CHANGES TO PROJECT DRAWINGS:

PROJECT: *Beatrice State Developmental Center - Central Heating Plant Upgrades*

DESCRIPTION: Addendum #2

BOILER PIPING SCHEMATIC

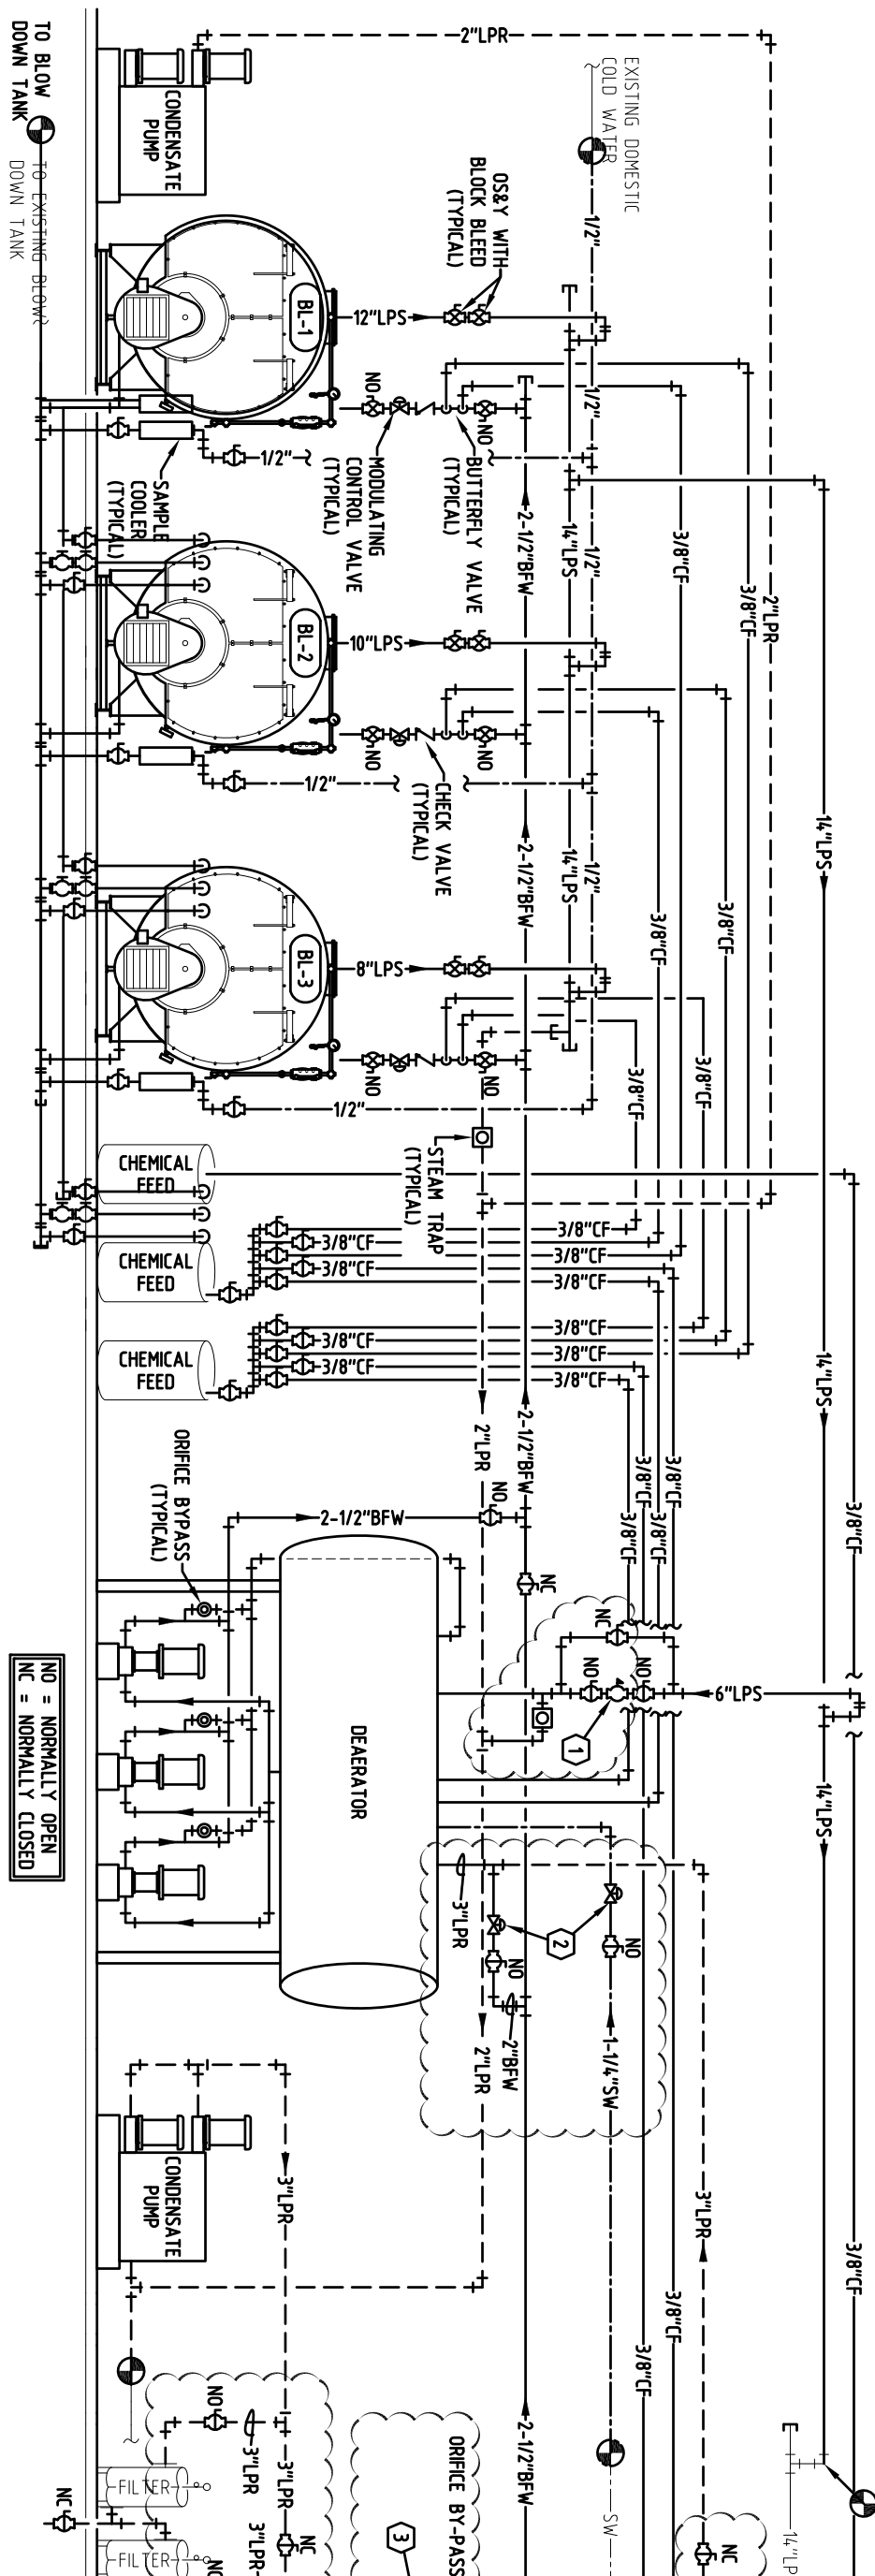
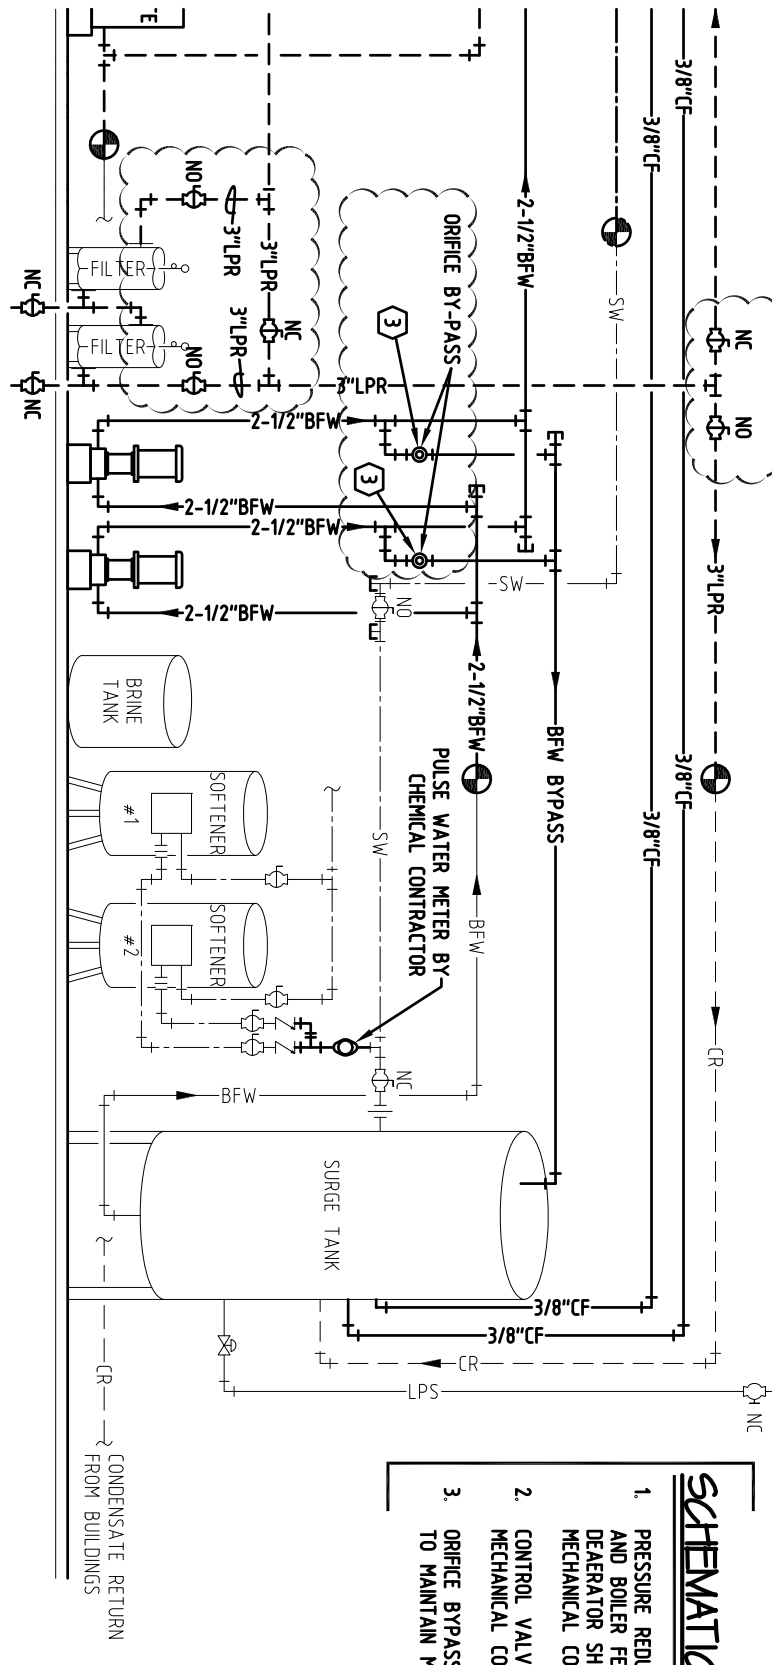
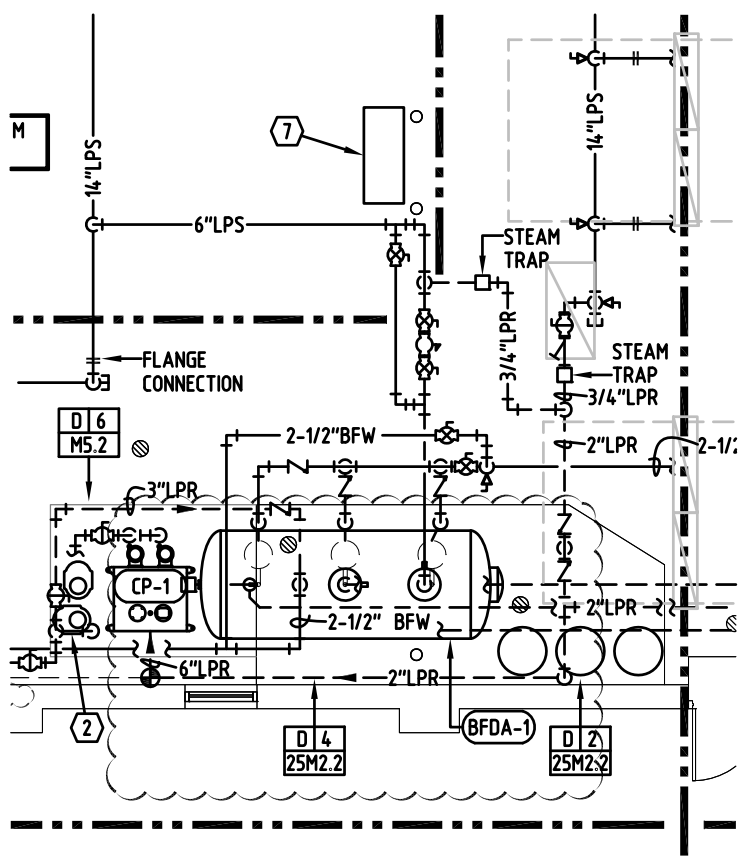
- 1) Schematic shall be labeled D1 – 25M2.0.
 - 2) Pressure reducing valve, soft water make up control valve and boiler feed water make up piping control valve serving Deaerator shall be provided with the BFDA-1 and installed by mechanical contractor.
 - 3) Note pointing to Orifice bypasses shall read "Orifice bypass and pipes shall be sized by pump manufacturer to maintain minimum flow as needed through the pumps."
 - 4) See revised piping detail and piping Mechanical Plan on ADD02.25M20-1 & ADD02.25M20-2
 - 5) Connect to existing rain water and route piping as shown on attached sheet ADD02.25M20-3
-

- SCHEMATIC NOTES**
1. PRESSURE REDUCING VALVE, SOFT WATER MAKE UP CONTROL VALVE AND BOILER FEED WATER MAKE UP PUMPING CONTROL VALVE SERVING DEAERATOR SHALL BE PROVIDED WITH THE BFDA-1 AND INSTALLED BY MECHANICAL CONTRACTOR.
 2. CONTROL VALVES PROVIDED BY DEAERATOR SUPPLIER INSTALLED BY MECHANICAL CONTRACTOR.
 3. ORIFICE BYPASS AND PIPES SHALL BE SIZED BY PUMP MANUFACTURER TO MAINTAIN MINIMUM FLOW AS NEEDED THROUGH THE PUMPS

FEED WATER DETAIL

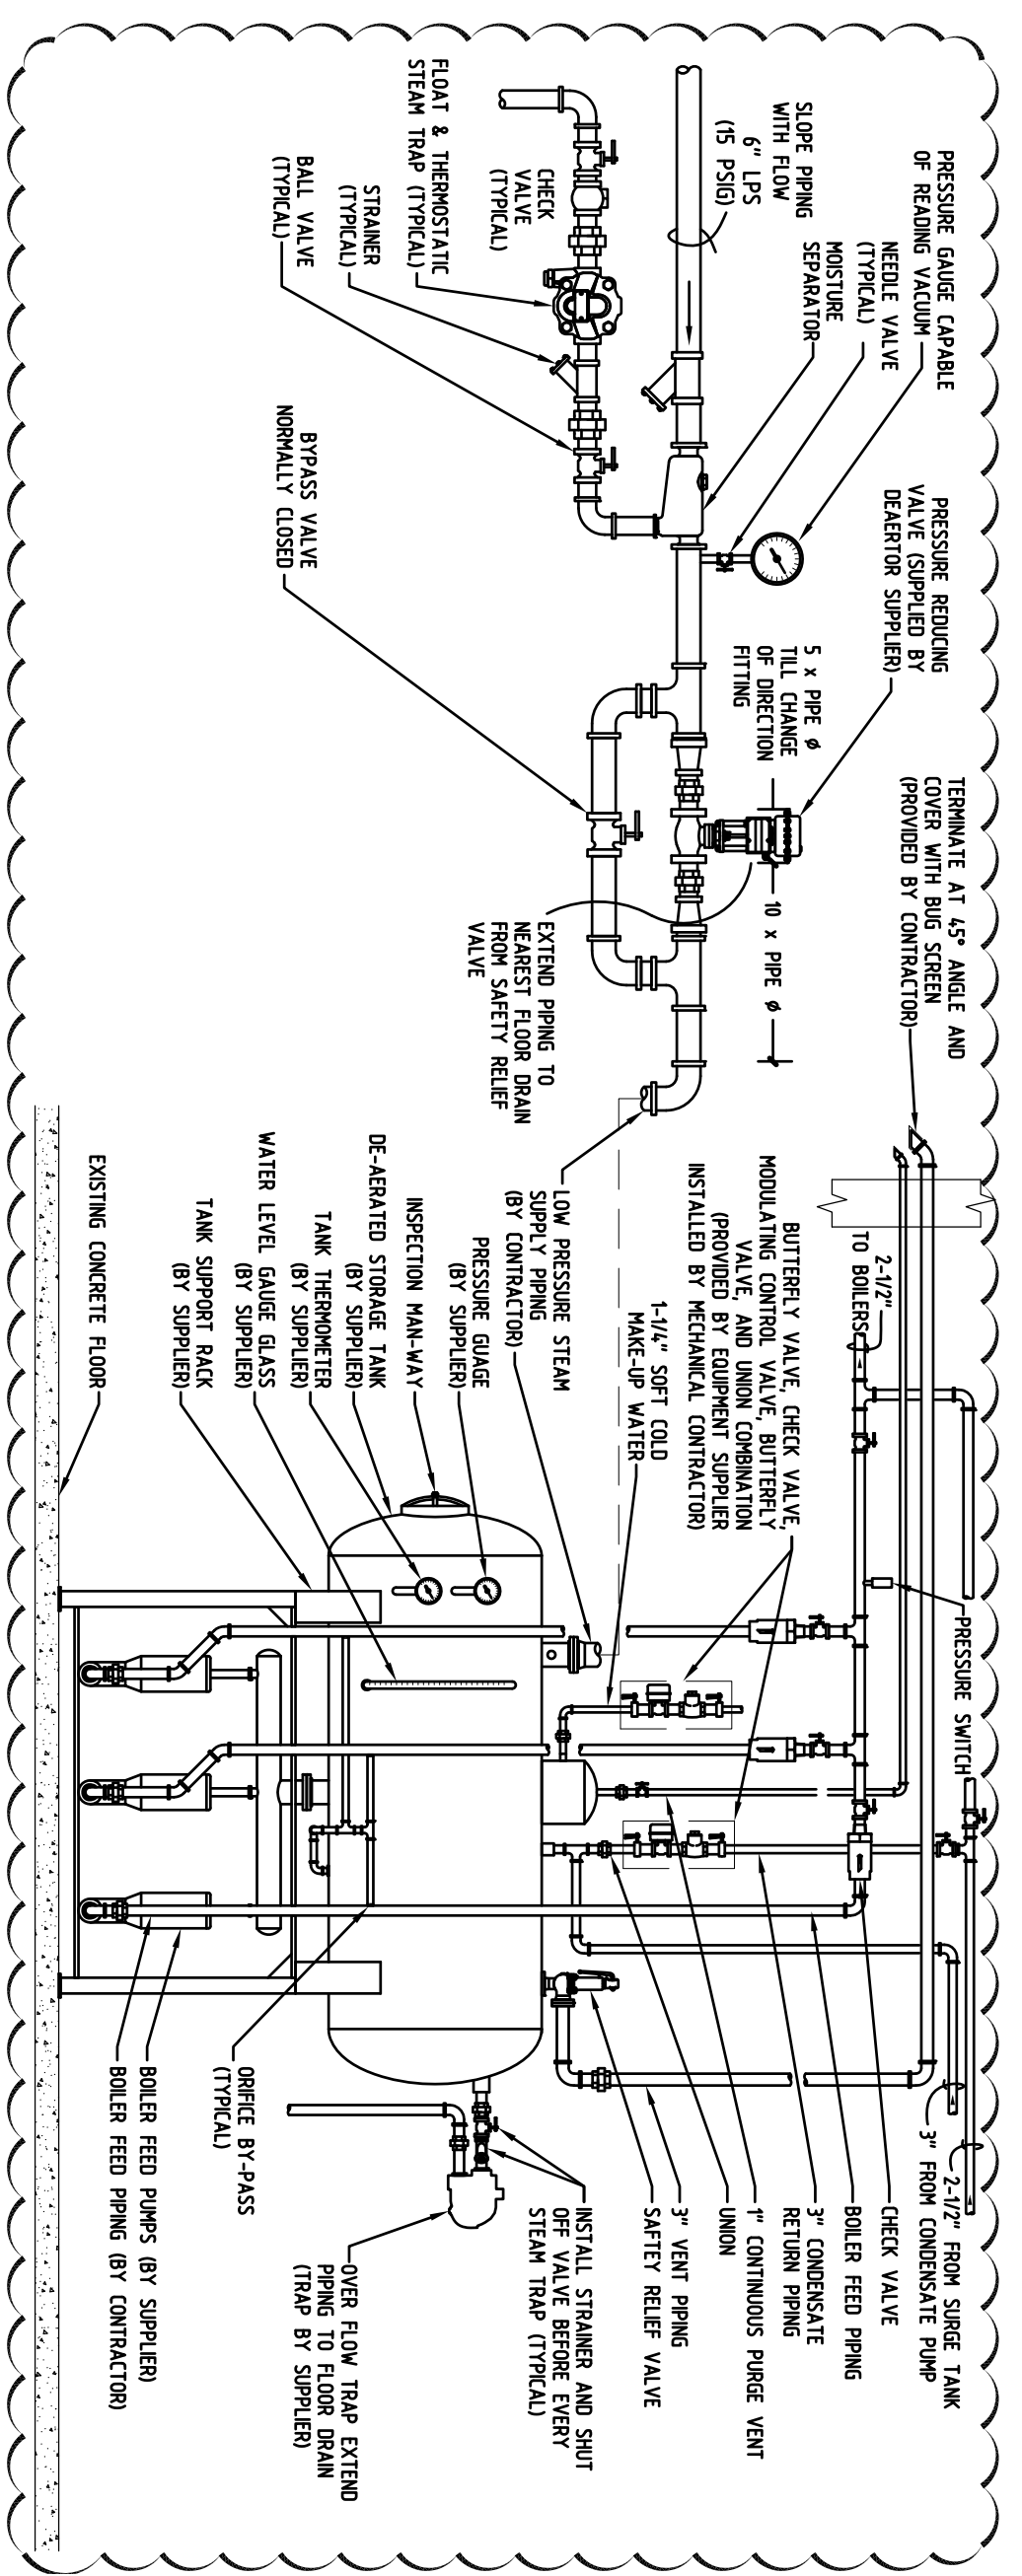
- 1) Domestic soft cold make-up water to BFDA-1 shall be 1-1/4".
- 2) The 1" label on the condensate return piping shall read 2".
- 3) See revised detail on ADD02.25M22-1
